April 23, 2004

U. S. Nuclear Regulatory Commission  
ATTN: Document Control Desk  
Washington, DC 20555-0001Peach Bottom Atomic Power Station, Units 2 & 3  
Facility Operating License Nos. DPR-44 and DPR-56  
NRC Docket Nos. 50-277 and 50-278Subject: Supplement to the Request for License Amendments Related to Application of  
Alternative Source Term, dated July 14, 2003

**Supplement to License Amendment Request for  
"PBAPS Alternative Source Term Implementation"**

**Response to Request for Additional Information**

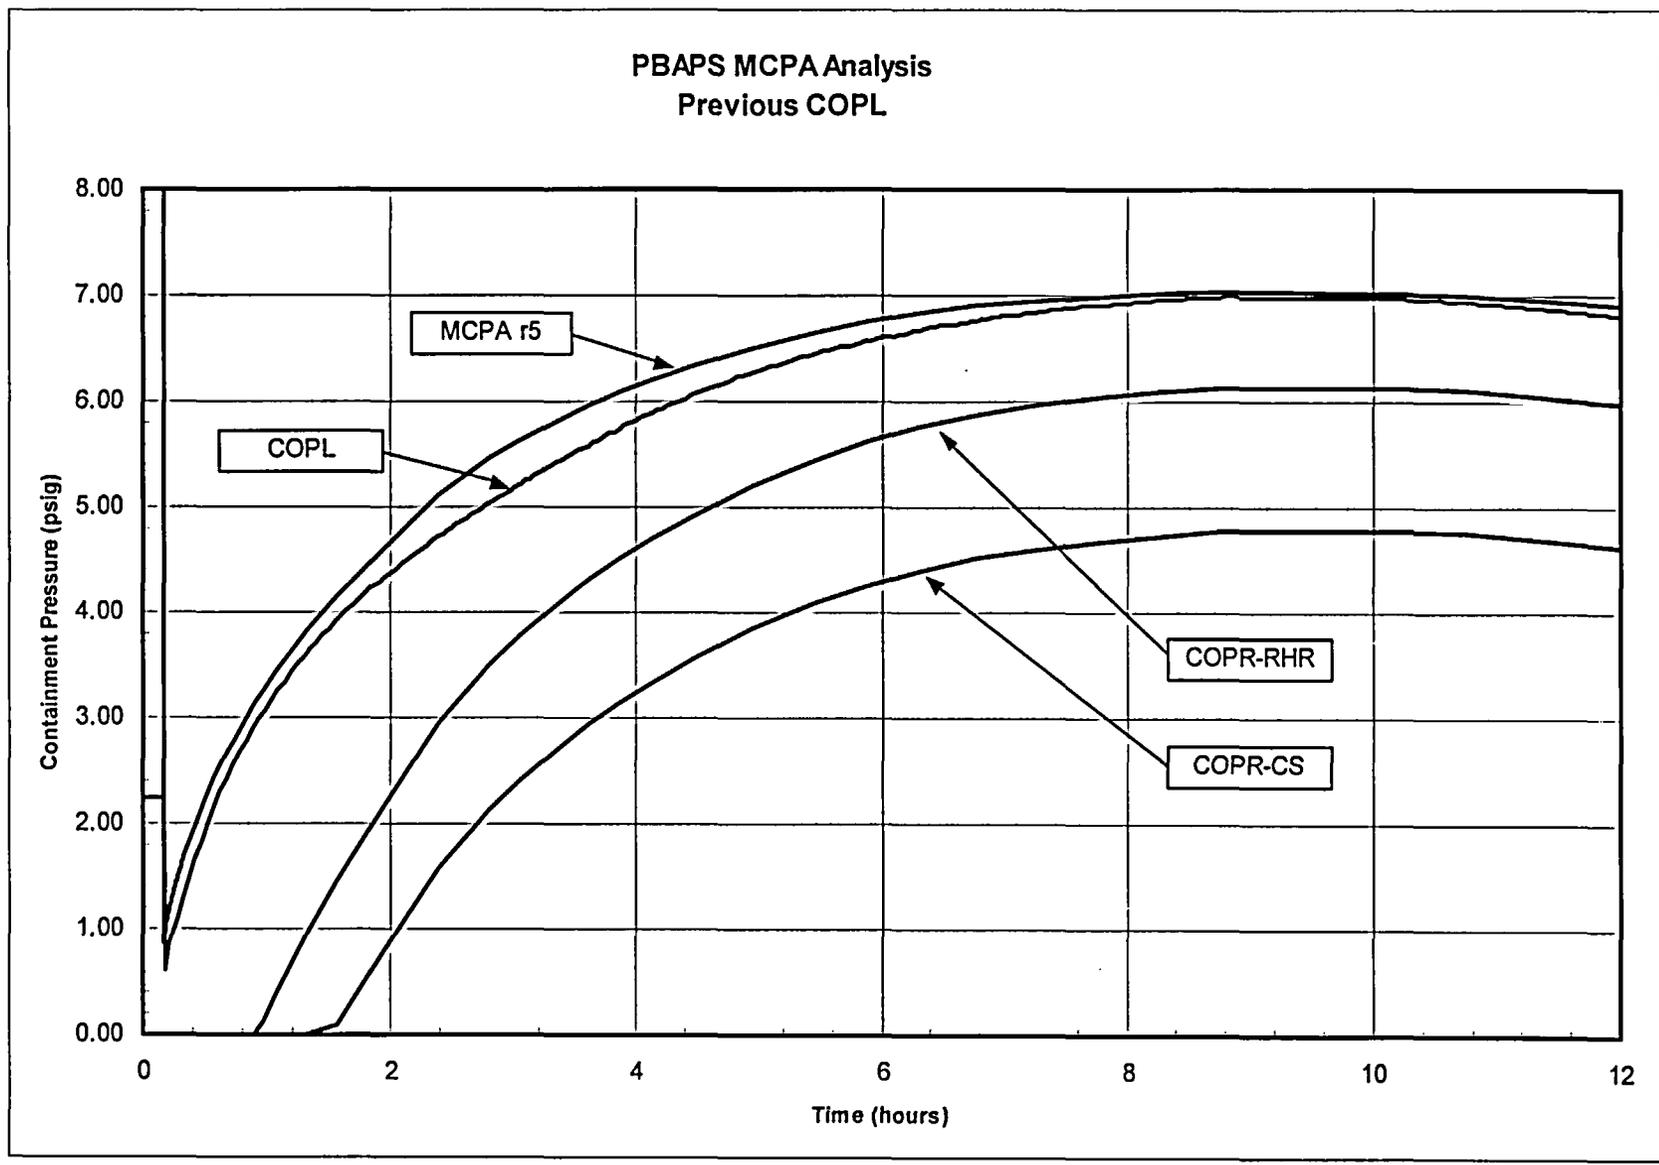
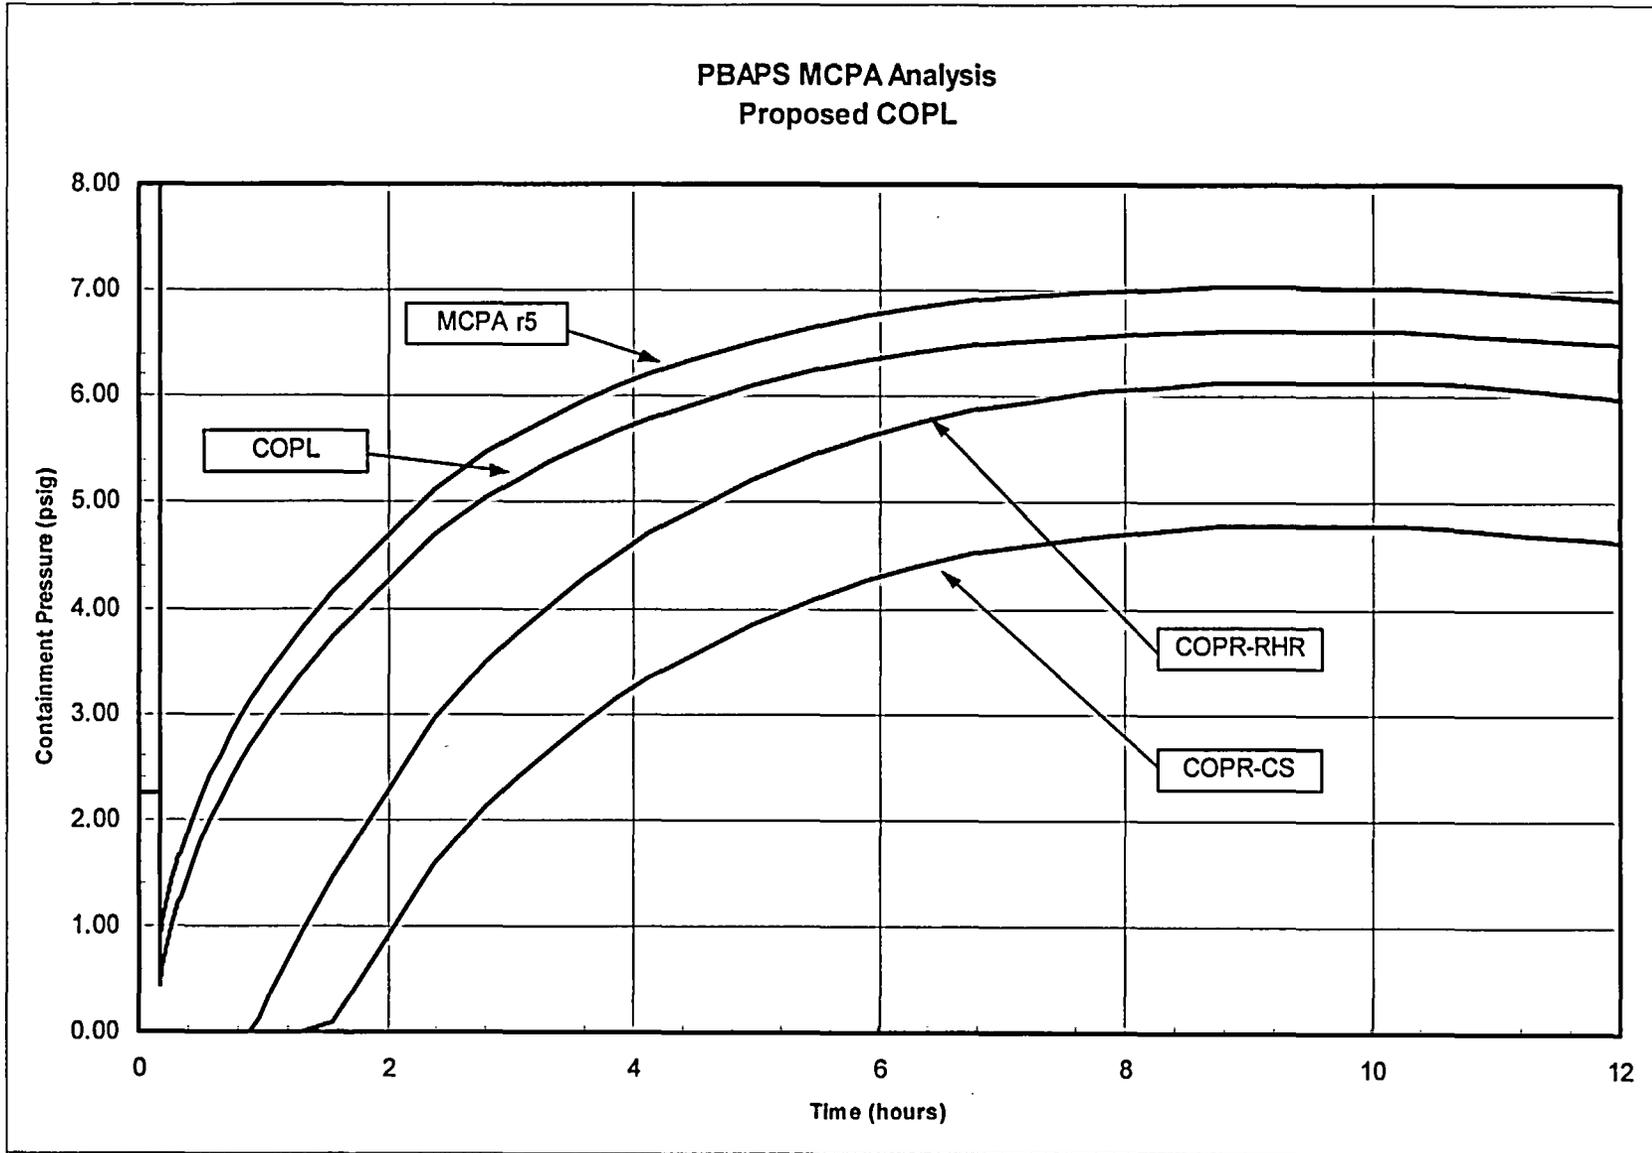
13. During the previous amendment review (Hutton, J. A., PECO Energy Company, to NRC, "Peach Bottom Atomic Power Station, Units 2 and 3 Response to May 10, 2000, Telephone Questions Regarding PECO Energy License Amendment Request Related to Generic Letter 97-04," June 29, 2000) it was stated that the margin between the MCPA and COPL was set at 1 foot (0.42 psid). The proposed amendment would decrease this margin to about 0.28 psid.

- a. Provide a justification for reducing this agreed to margin.
  - b. Provide a comparison of the COPL value to the COPR (containment overpressure required) value for the residual heat removal (RHR) and core spray pumps for the most limiting event(s), including the margin to the COPL value before and after the proposed change to the MCPA/COPL calculation.

- (a) Although the COPL line was derived using a 1 foot margin to the MCPA, it is our understanding that, like the original Peach Bottom FSAR containment overpressure limit line, the NRC SER has established the COPL line itself, "depicted on UFSAR Figure 5.2.16" as the limit, rather than the maintaining of a specified margin to the MCPA. With the COPL being a fixed line, the proposed AST changes would have reduced the MCPA margin to the previous COPL from 1 foot of head ( $7.41 - 6.99=0.42$  psid) to essentially zero ( $7.04 - 6.99=0.05$  psid). Consequently, a new COPL limit needs to be proposed.

If instead of COPL being a fixed line, maintaining a 1 foot of head margin to the MCPA were the case, adequate overpressure margin would still be available to satisfy the NPSH requirements of the RHR pump during the design basis LOCA. A 1 foot of head margin to the new MCPA would produce a peak COPL of 6.62psig ( $7.04 - 0.42=6.62$  psig), which still provides another foot of margin to the peak COPR for RHR of 6.14 psig ( $6.62 - 6.14=0.48$  psid).

The COPL line that was proposed with the AST amendment request preserved the relative relationship between the COPR, COPL, and MCPA from the previous NRC review. With about a third of the available margin between MCPA and COPR being assigned to the COPL, the new proposed COPL line still maintains about a third of the available margin to the MCPA (0.69 foot, approx. 0.29 psid).

- (b) The following table summarizes the COPL, MCPA, and COPR data provided in the attached charts, with a COPL based on a 1 foot margin to the MCPA.

# FIGURE 1

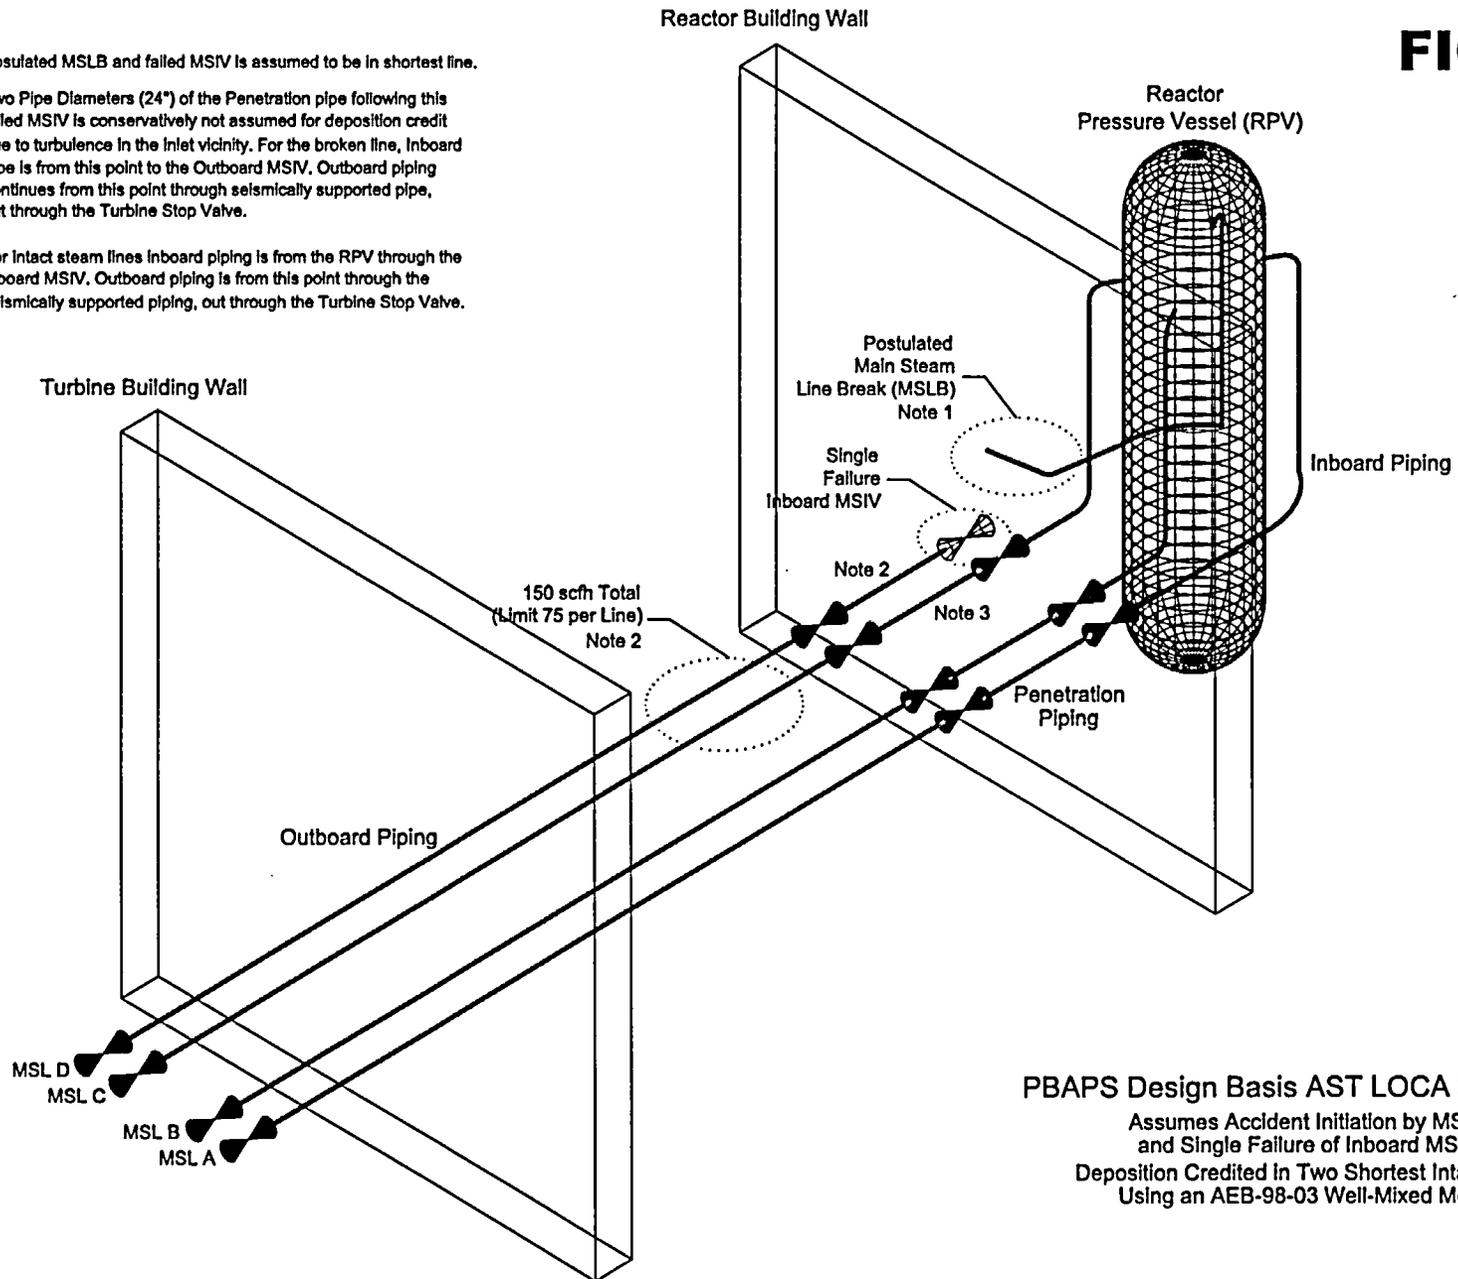
20. On Page 15 of Attachment 1 of the submittal, the second paragraph states that Exelon has used the Brockmann-Bixler model for main steamline deposition. The discussion and the data in Table 5 are insufficient to support an NRC staff confirmation. Please provide the following information.

- A single-line sketch of the four main steamlines and the isolation valves. Annotate this sketch to identify each of the control volumes assumed by Exelon in the deposition model.

Figure 1 in this attachment, shows a single-line sketch of the four main steam lines and the isolation valves. This figure shows control volumes and break locations.

1. Postulated MSLB and failed MSIV is assumed to be in shortest line.
2. Two Pipe Diameters (24") of the Penetration pipe following this failed MSIV is conservatively not assumed for deposition credit due to turbulence in the inlet vicinity. For the broken line, Inboard pipe is from this point to the Outboard MSIV. Outboard piping continues from this point through seismically supported pipe, out through the Turbine Stop Valve.
3. For intact steam lines inboard piping is from the RPV through the Inboard MSIV. Outboard piping is from this point through the seismically supported piping, out through the Turbine Stop Valve.

Assumes Accident Initiation by MSLB  
and Single Failure of Inboard MSIV  
Deposition Credited In Two Shortest Intact Lines  
Using an AEB-98-03 Well-Mixed Model
